The Legacy Way Project Application for Project Change – Conveyor Tunnel

CO-WC-RP-0002 Rev B

22 July 2011

Figure 2: Proposed Conveyor Tunnel (proposed change)

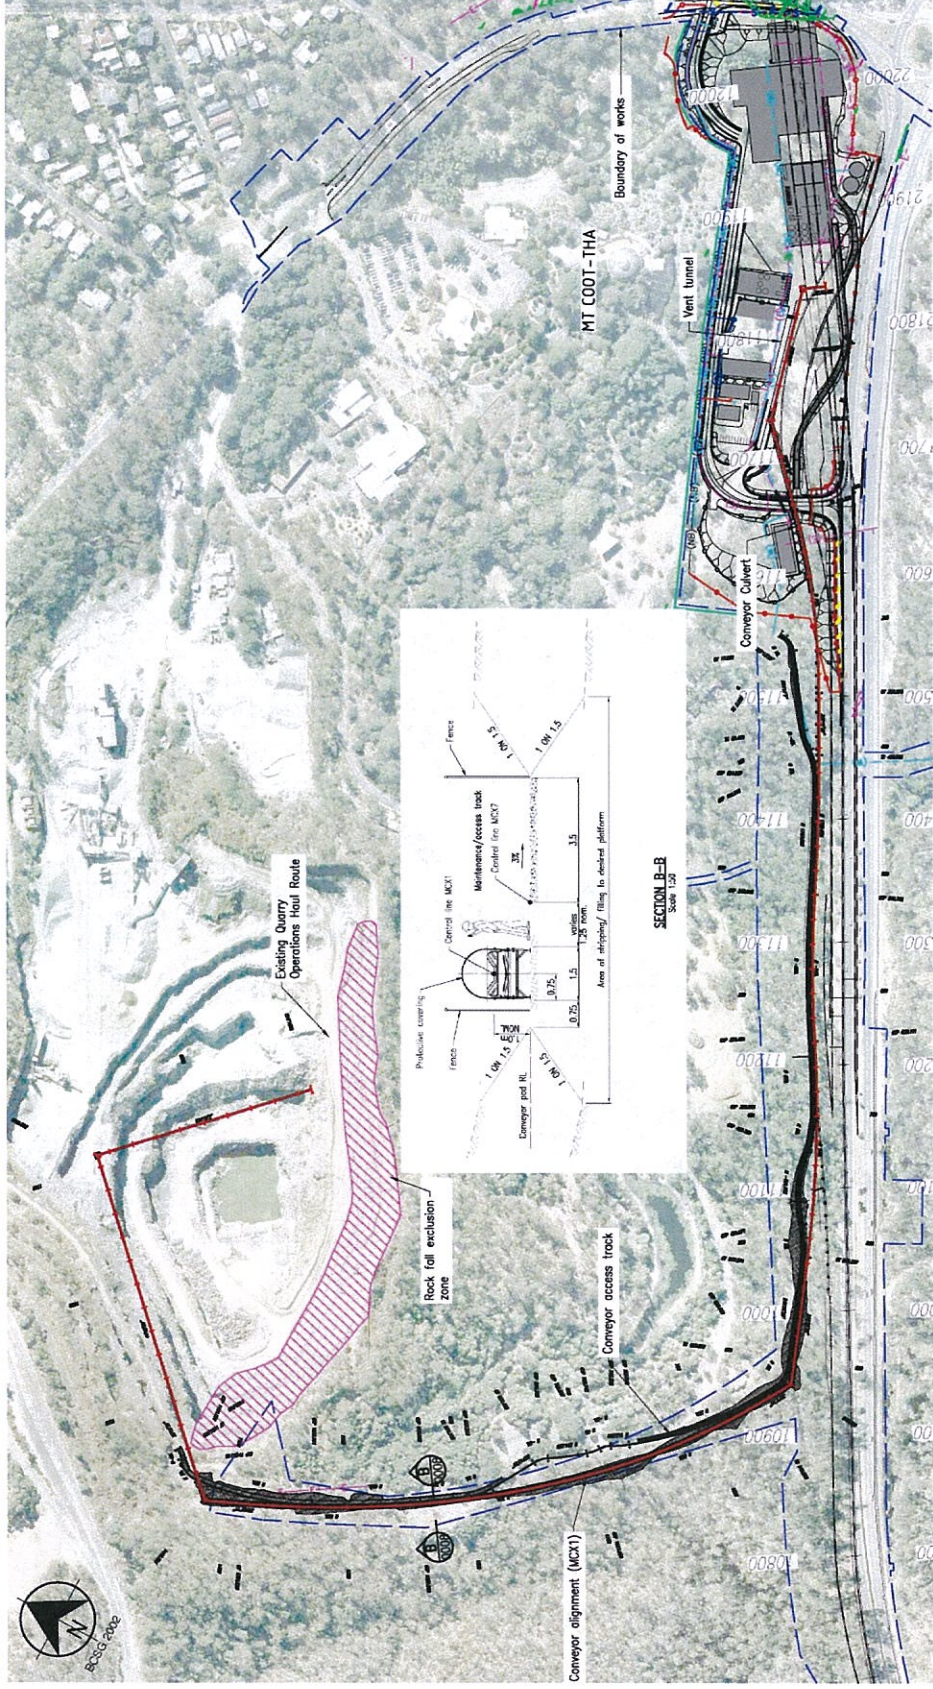
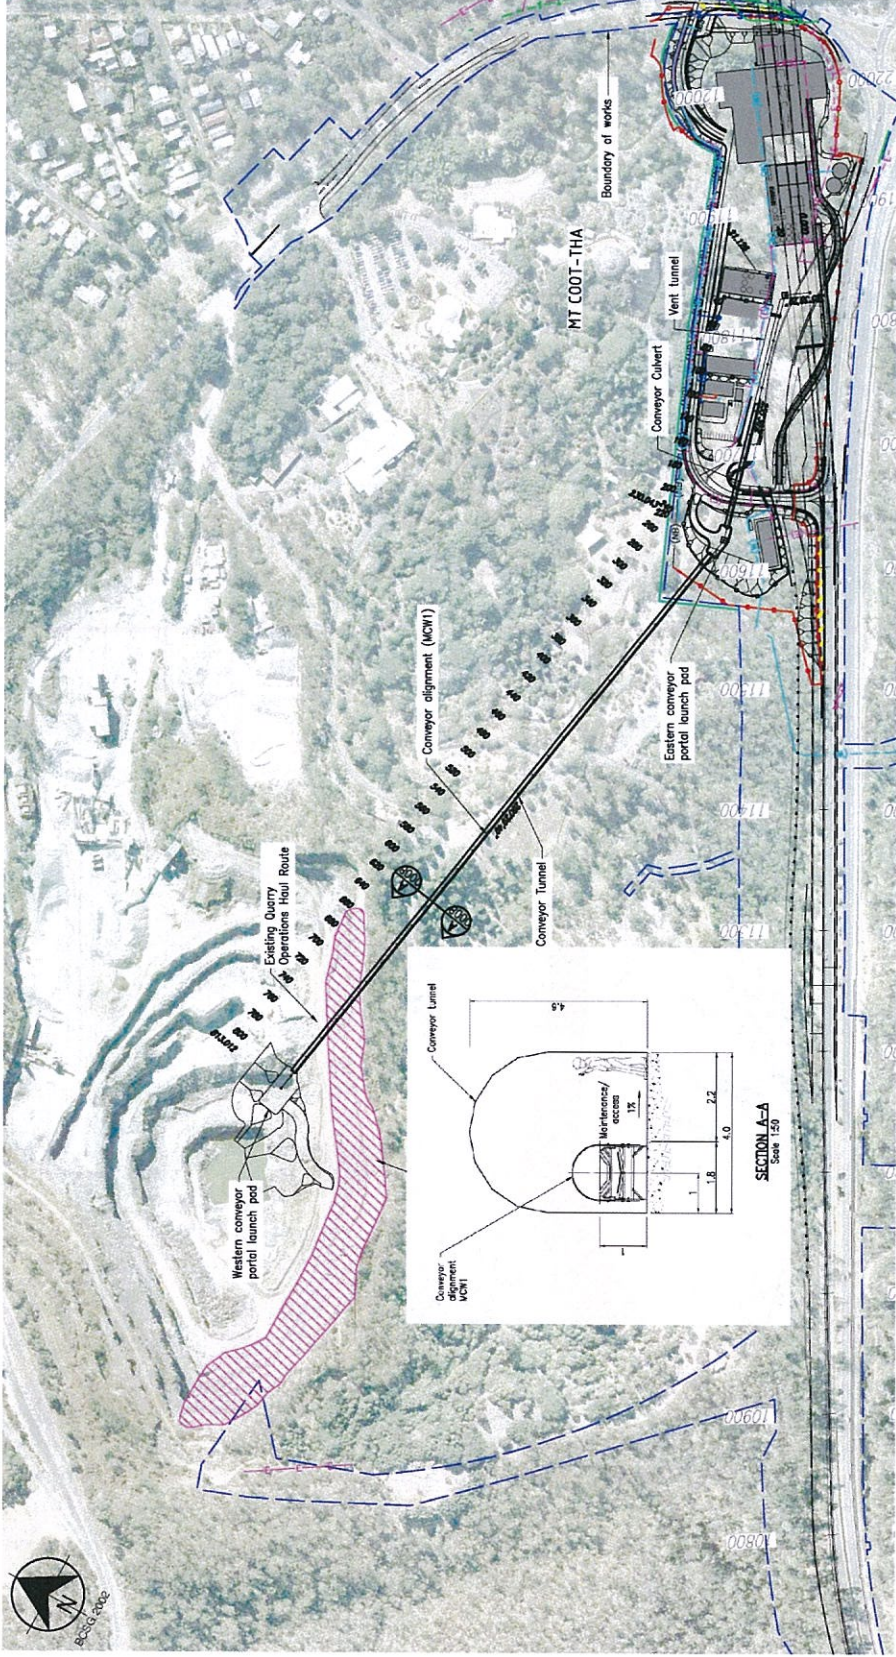
The proposed alignments and typical cross sections of the both the Overland Conveyor and Tunnel Conveyor are shown on Figure 1: Current Overland Conveyor (approved project) and Figure 2: Proposed Conveyor Tunnel (proposed change) respectively of this report. As shown, the Overland Conveyor route would be approximately 1,750m long from the western worksite along the northern side of the widened Western Freeway, and north through existing Mt Coot-tha bushland to the top of the Quarry. The Conveyor Tunnel route would be approximately 850m long from the western worksite directly to lower level in the Quarry at depths of between 15 and 35m below the public areas of the Brisbane Botanic Gardens.

The proposed conveyor tunnel is shown on Figure 2: Proposed Conveyor Tunnel (proposed change) of this report. The length of the proposed conveyor tunnel would be approximately 600m from where it leaves the western worksite directly to the Quarry. This route would take it under public areas of the Brisbane Botanic Gardens and under bushland to the Quarry.

The conveyor alignment is shown in Figure 2: Proposed Conveyor Tunnel (proposed change).

BRISBANE CITY COUNCIL
LEGACY WAY
CONVEYOR TUNNEL AND ASSOCIATED WORKS
CONVEYOR TUNNEL LAYOUT PLAN

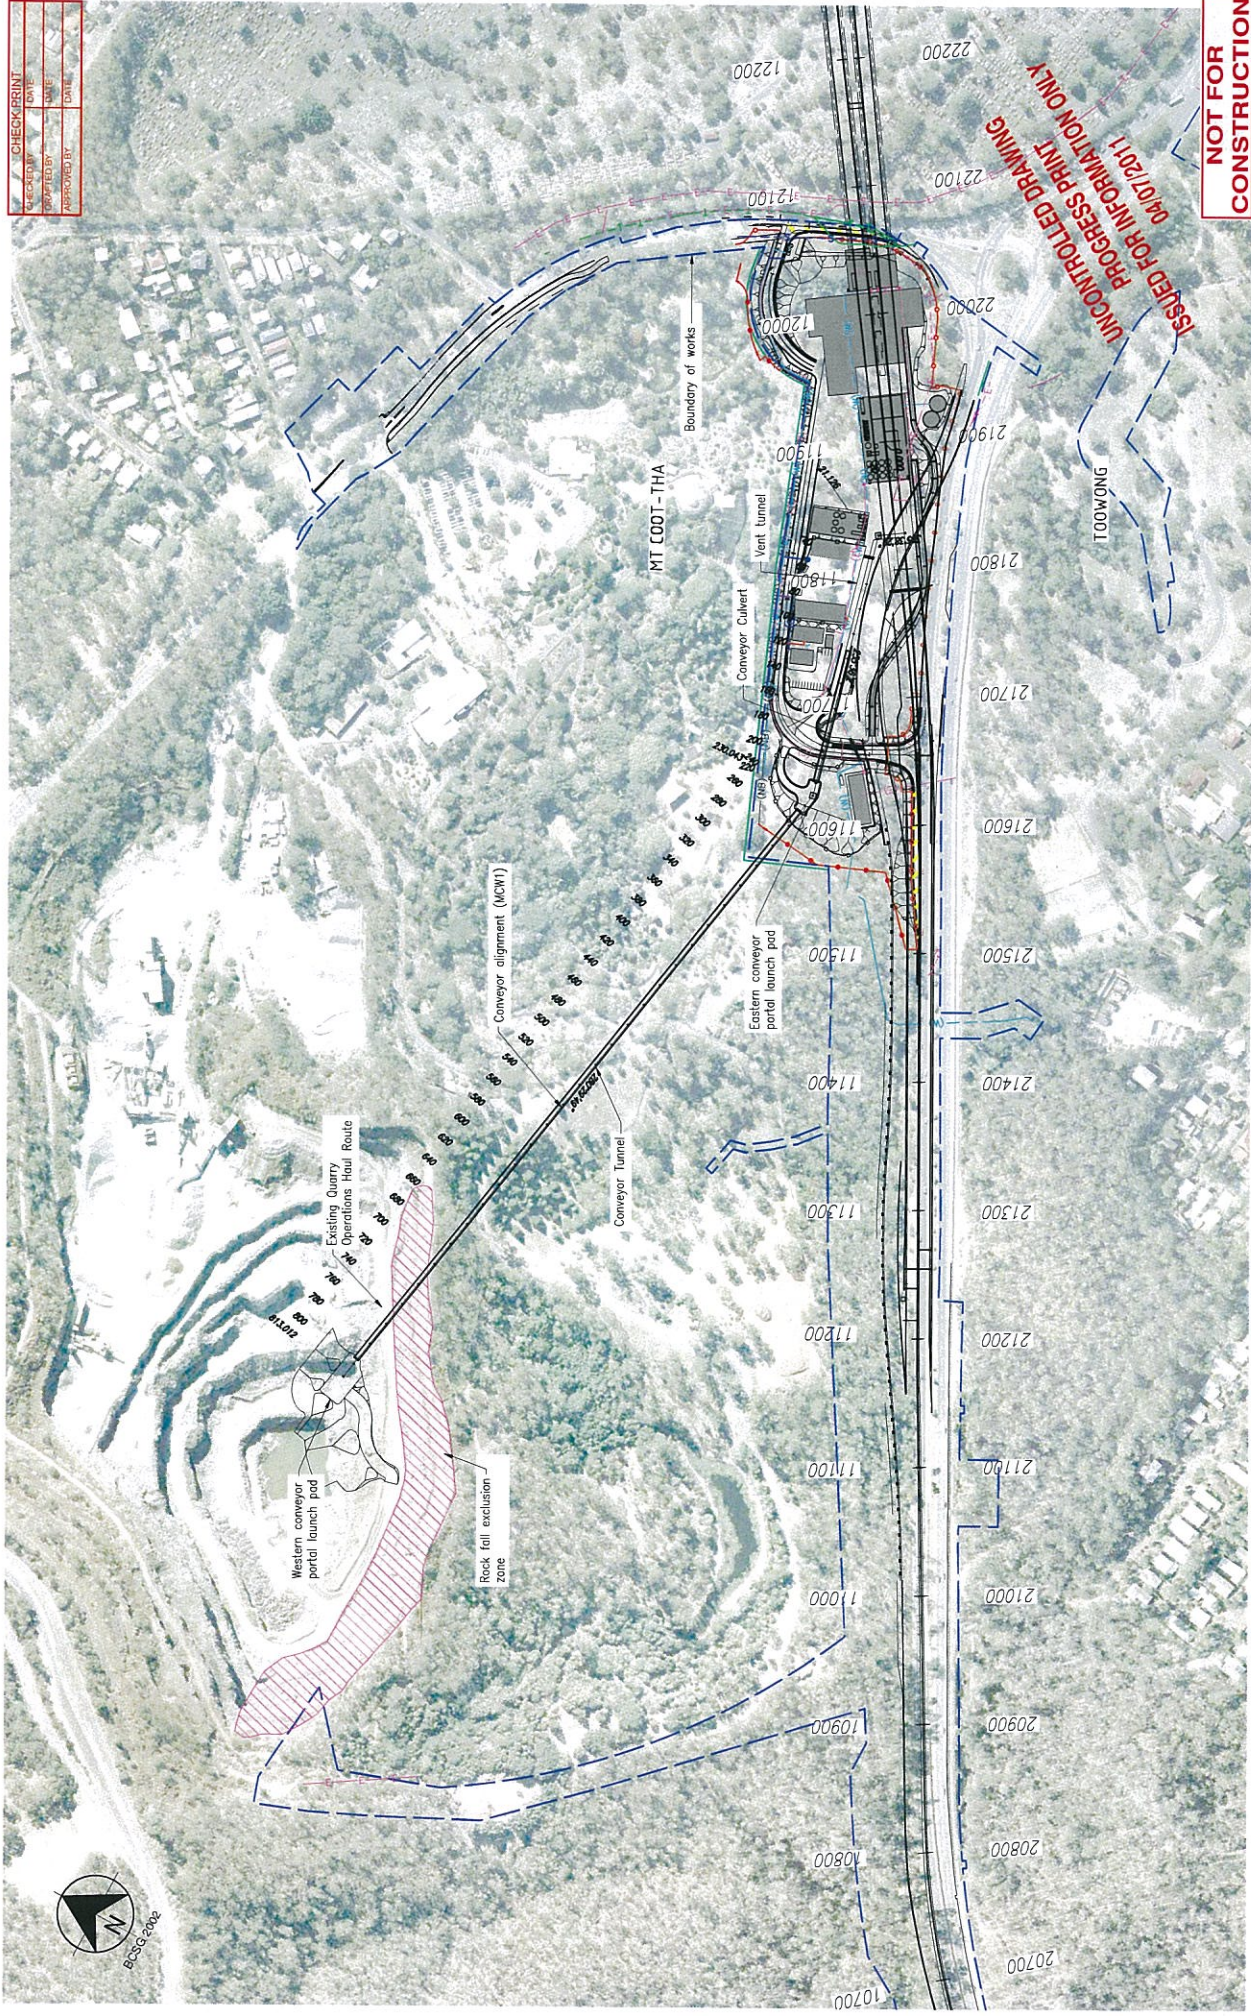
The tunnel section of the conveyor route passes under public areas at the south west region of the Brisbane Botanic Gardens. However this poses no danger to the public during either construction, operation or closure of the conveyor tunnel.

It is noted that the conveyor tunnel alignment crosses the proposed alignment of the future Inner Orbital tunnel motorway route at around the mid-point of the conveyor tunnel. At this location the conveyor tunnel is 35 m deep from ground surface to tunnel crown and well within the slightly weathered to fresh rock horizon. Whilst the proposed depth of the future Inner Orbital tunnel is unknown, given the quality of the rock being tunnelled through, allowance for this future infrastructure will be made by either backfilling a portion of the conveyor tunnel allowing the Inner Orbital to tunnel through this backfilled ground or a mined junction between two tunnels is also possible. By potentially not backfilling the conveyor tunnel after completion of Legacy Way an opportunity could be realised to use the conveyor tunnel for geotechnical planning and design on the Inner Orbital. Should geometrics not allow the conveyor tunnel to be incorporated into this planning of the Inner Orbital, the conveyor can be backfilled over the length that it influences the inner orbital tunnels ahead of tunnelling activities for that project.

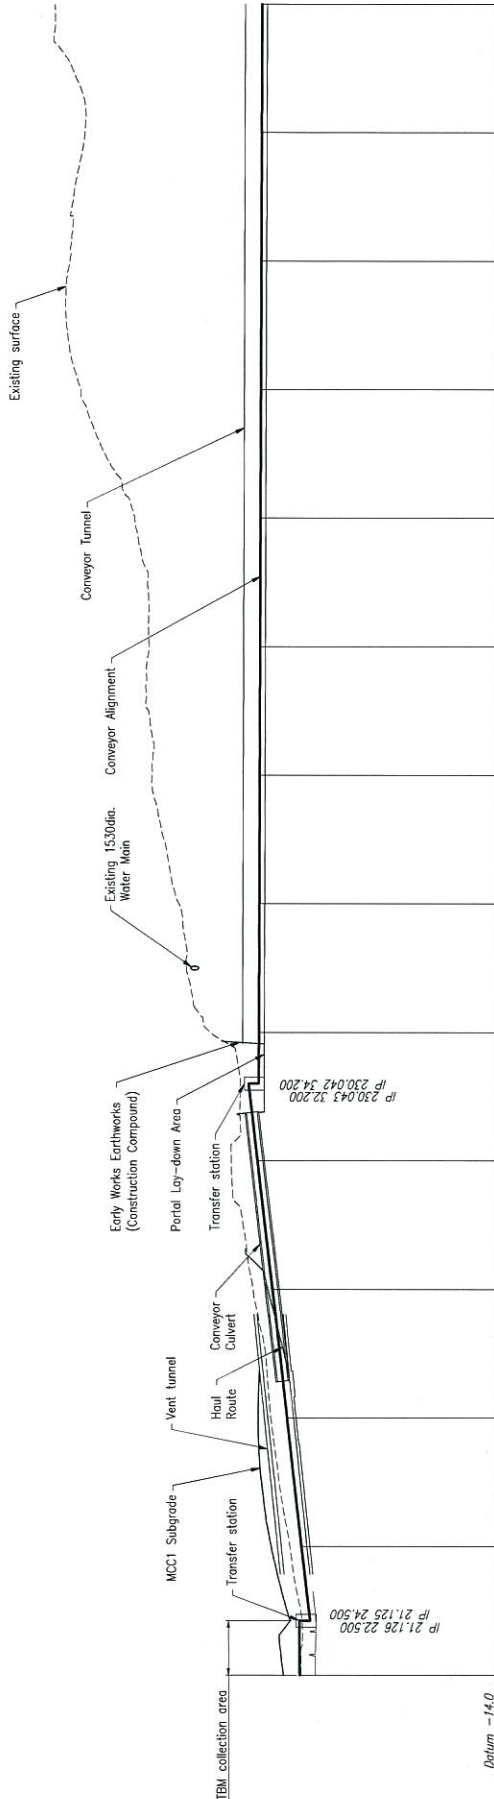
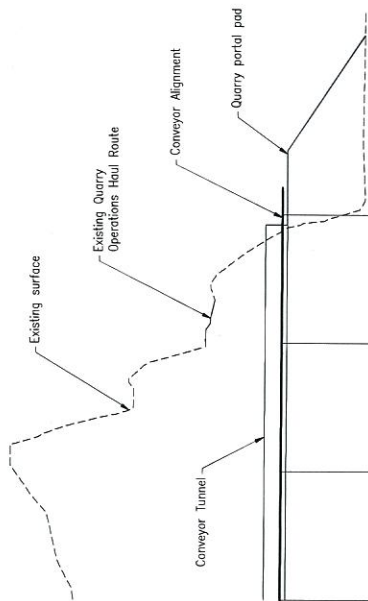
The spoil conveyor picks up spoil from the transverse feed conveyor in the ventilation tunnel at RL 24.1 (approx.) and rises along the ventilation tunnel at a grade of 5.6% until chainage 160 where the vent tunnel structure stops and changes to an earth cut (RL 29.717). The cut alignment moves south and rises at up to 8 per cent grade to join the site access road. The conveyor culvert maintains the 5.6% grade until it daylights at the ventilation station platform at RL 32.2.

The tunnel starts at chainage 240 with the floor set at RL 32.159, approximately 4.4 metres below the ventilation station platform. From this portal the tunnel falls at a constant grade to exit in the Quarry wall at RL 31.022, a grade of -0.207%.

The conveyor is generally underground with depths to the conveyor belt starting at 2.248 metres in the ventilation tunnel to 5.289 metres at the exit onto the ventilation platform. The depth of the conveyor through the tunnel from the existing ground surface varies from 11.5 metres at the eastern portal to a maximum depth of 52 metres as the tunnel passes under the crest of the Quarry wall. Under the public areas of the Brisbane Botanic Gardens, the conveyor tunnel would have between approximately 15m of cover at chainage 300 and 35m of cover at chainage 550.
